Our File Ref: B25176TL001_REVA

RE: PROPOSED RESIDENTIAL SUBDIVISION
MERINGANDAN ROAD, MERINGANDAN, QLD 4352
TRAFFIC ENGINEERING RESPONSE TO COUNCIL INFORMATION REQUEST

This letter has been prepared in response to Toowoomba Regional Council's (TRC) Information Request dated 13 October 2025 (Ref: RAL/2025/5992). The Information Request is in relation to a Reconfiguring a Lot (ROL) Development Application (DA) for a residential subdivision located along Meringandan Road, Meringandan, QLD 4352. The proposal involves 199 residential lots and two (2) balance lots. The site is formally described as Lot 3 on AG4138 and Lot 1 on RP27298 with a total site area of approximately 36.813ha.

CONCEPT PLAN - OVERALL

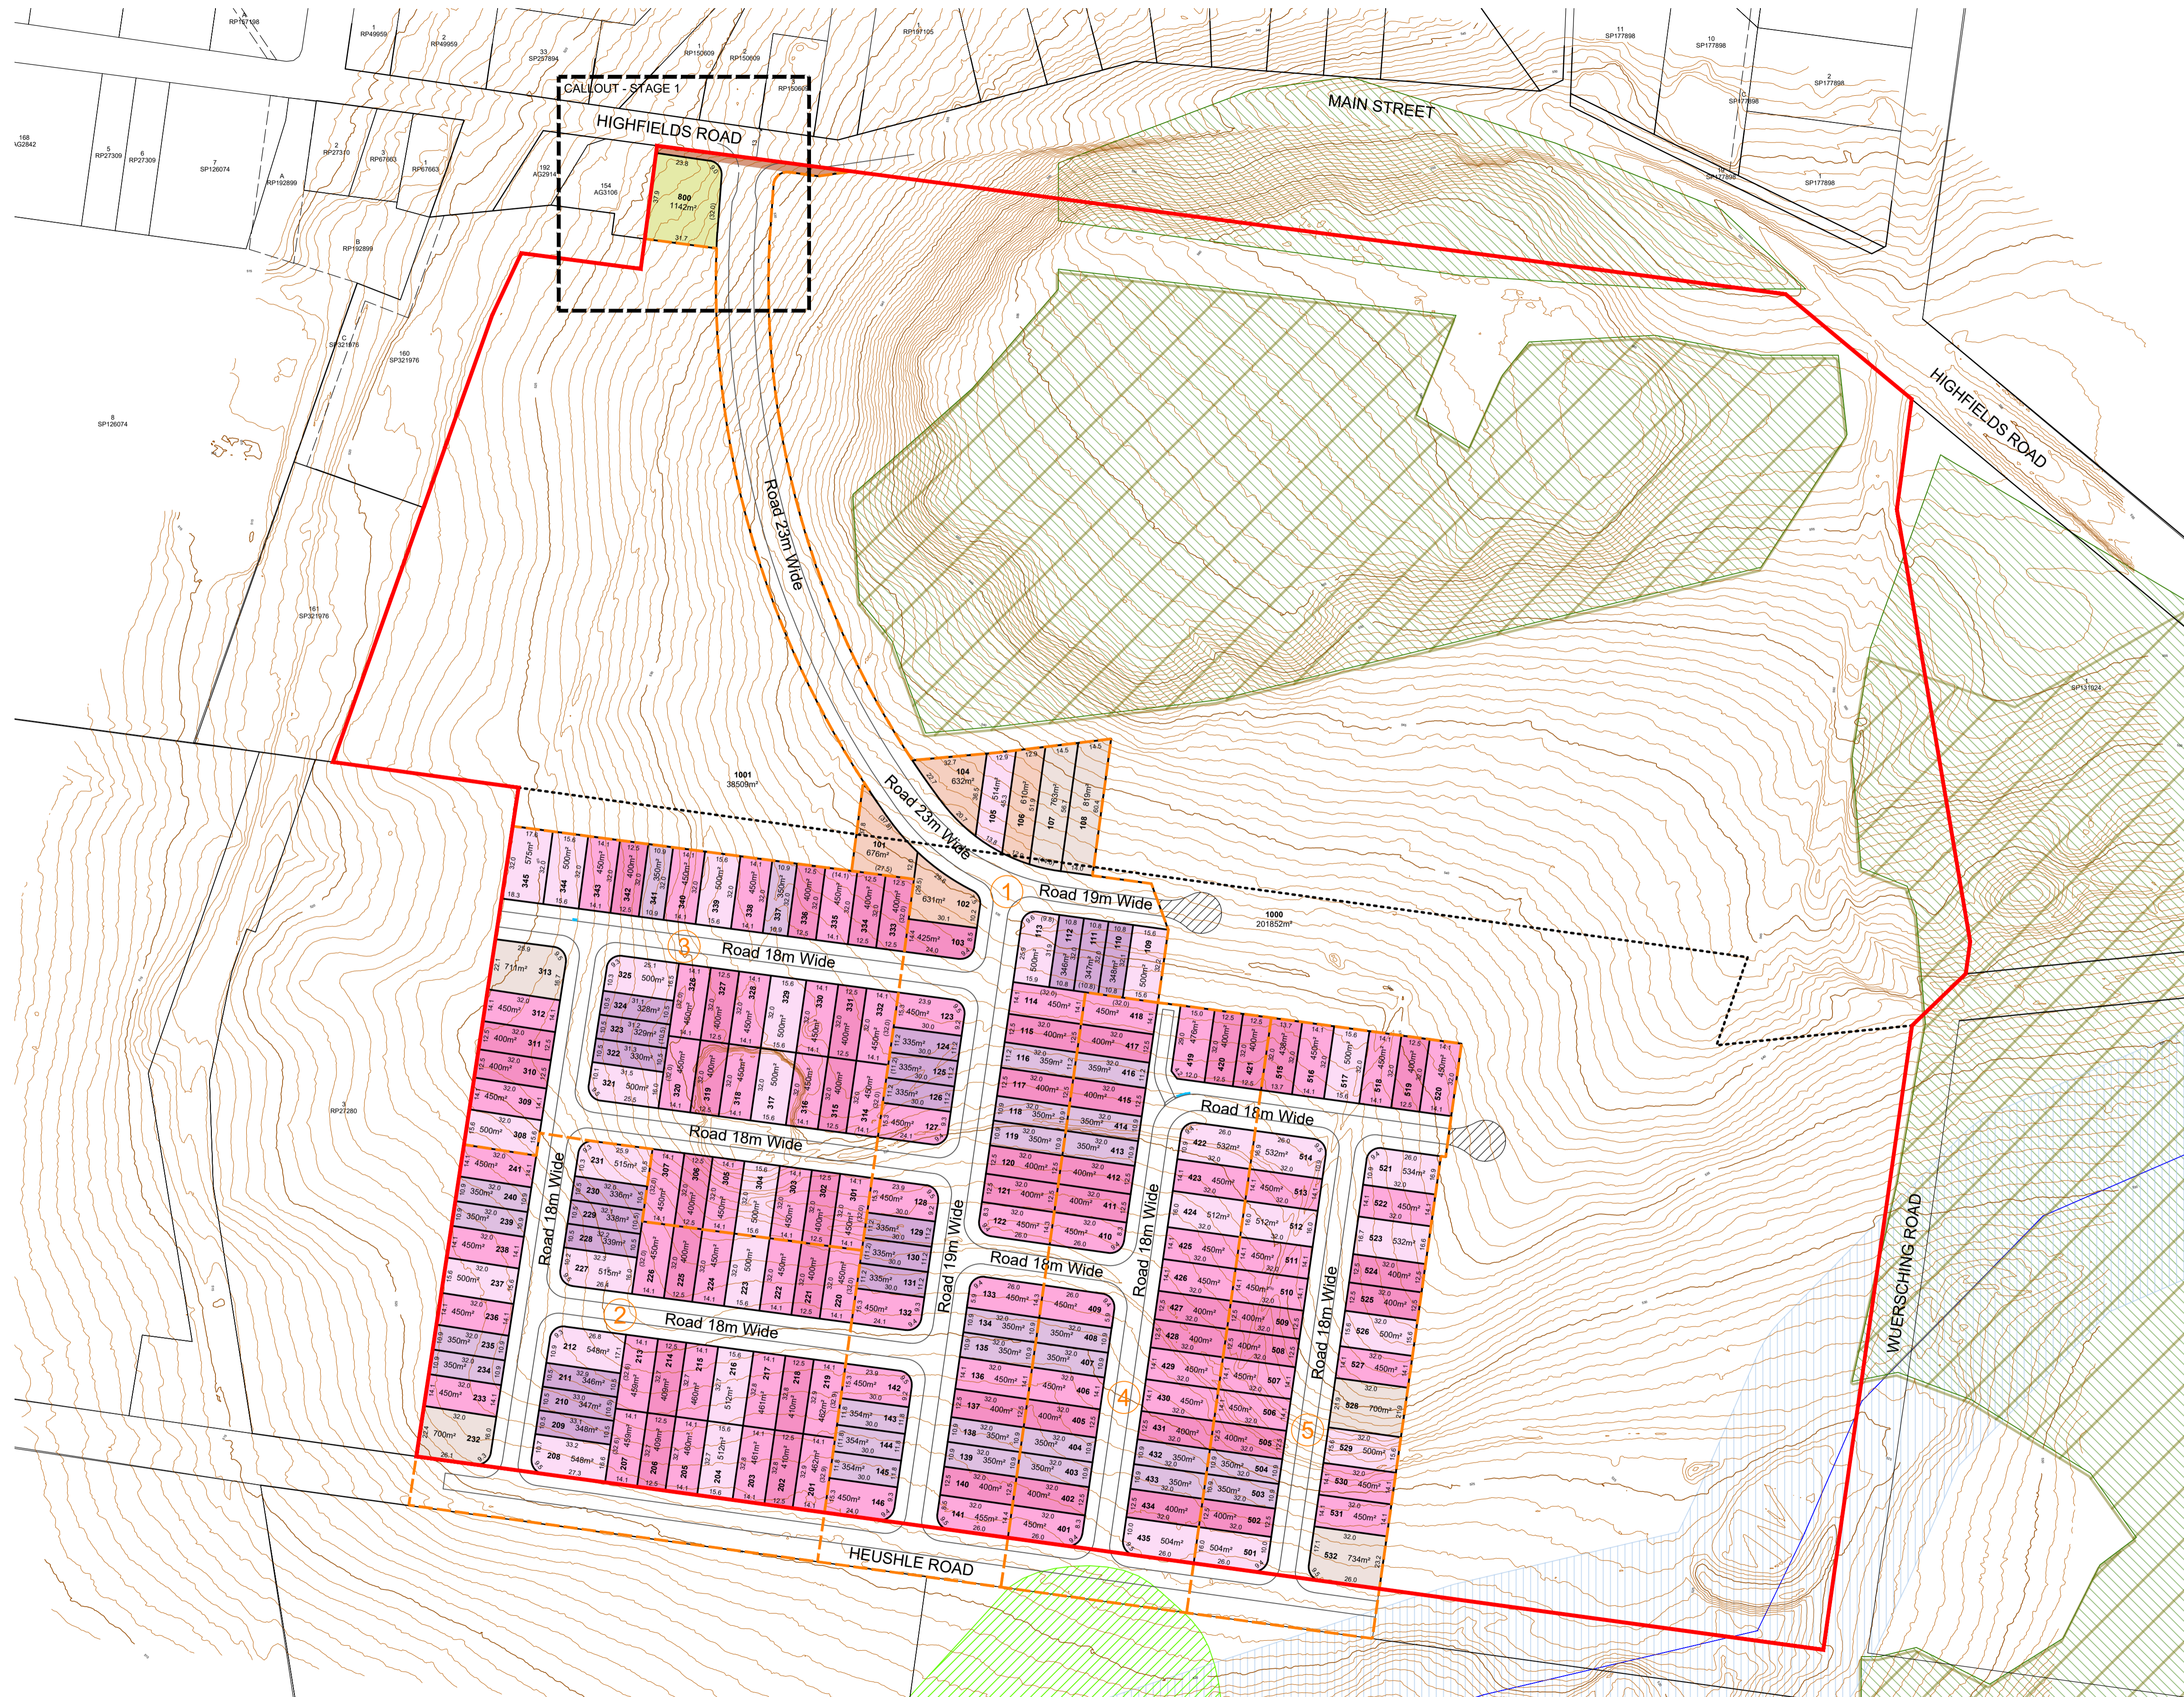
The proposed layout does not provide for any safe alternative access, inconsistent with the Reconfiguring a Lot Code. A subdivision of this scale is required to be provided with at least two (2) fully functioning connections to the road network.

Provide amended plans which establish a second road connection to the constructed external road network.

The lot layout results in long block lengths particularly along the western side of Stages 2 and 3 and between Stages 1 and 4.

- (a) Provide a mid-block road connection to adjoining land to the west; and*
- (b) Replace the pedestrian connection between Stages 1 and 4 with a road connection.*

Please refer to the response prepared by Saunders Havill. We note due to environmental constraints a secondary connection is not feasible at this stage, however an emergency road connection to Main Street towards the north-east will be maintained as shown in the Structure Plan enclosed within Attachment 1 of this letter.

Please refer to the updated site layout included in Attachment 1. The existing pedestrian connection between Stages 1 and 4 has now been replaced with a road connection.

In our view a mid-block road connection for the western lots is not deemed necessary from a traffic perspective as these lots are within close proximity to Heushle Road towards the south and the 18m wide Access street towards the north, both of which will provide suitable connectivity and capacity for traffic generated by the site to the west.

STRUCTURE PLAN

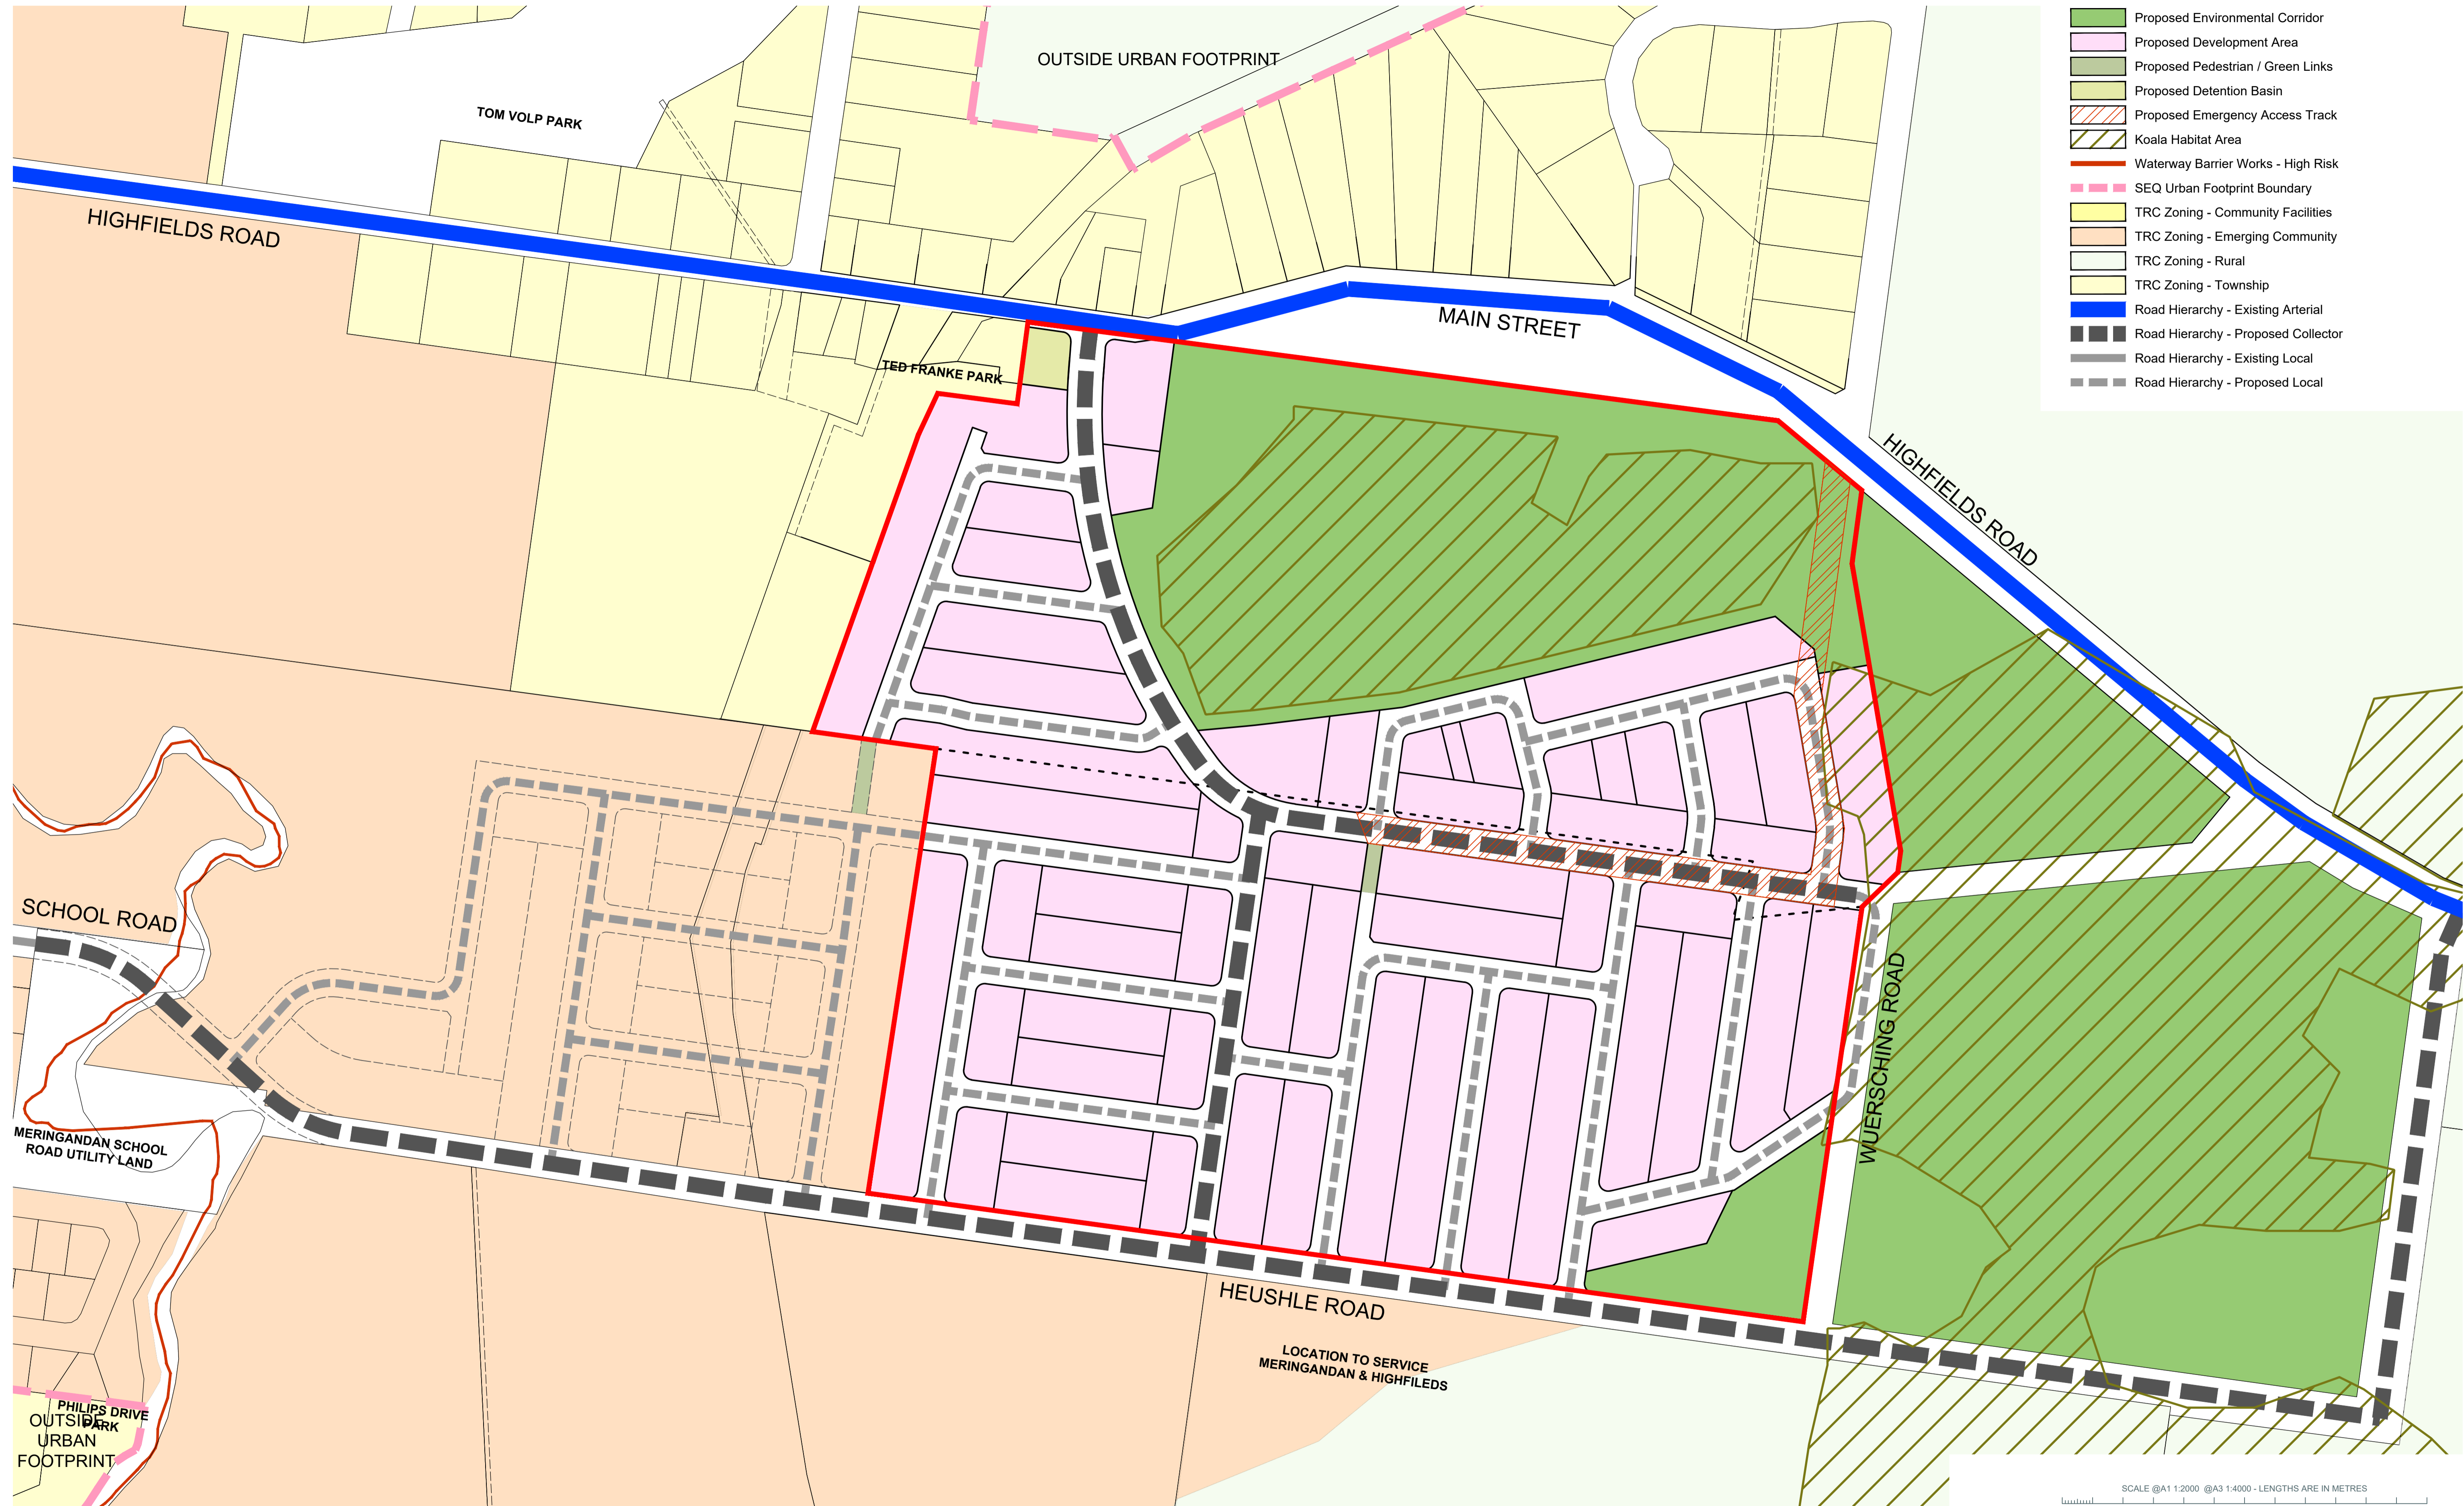
- (h) Has not considered walk and cycle connections.*

Please refer to the updated Site Layout and Structure Plan enclosed within Attachment 1 of this letter, which shows that pedestrian footpaths will be provided on the internal road network in accordance with TRC's typical cross section drawings. Internal Pedestrian / Green Links are also proposed within the development site. We note there are no existing pedestrian connections external to the development site along Main Street, however the road dedication will provide sufficient verge width for pedestrian pathways to be provided in the future. If required, Council can condition the delivery of a pathway along the site frontage connecting to the west.
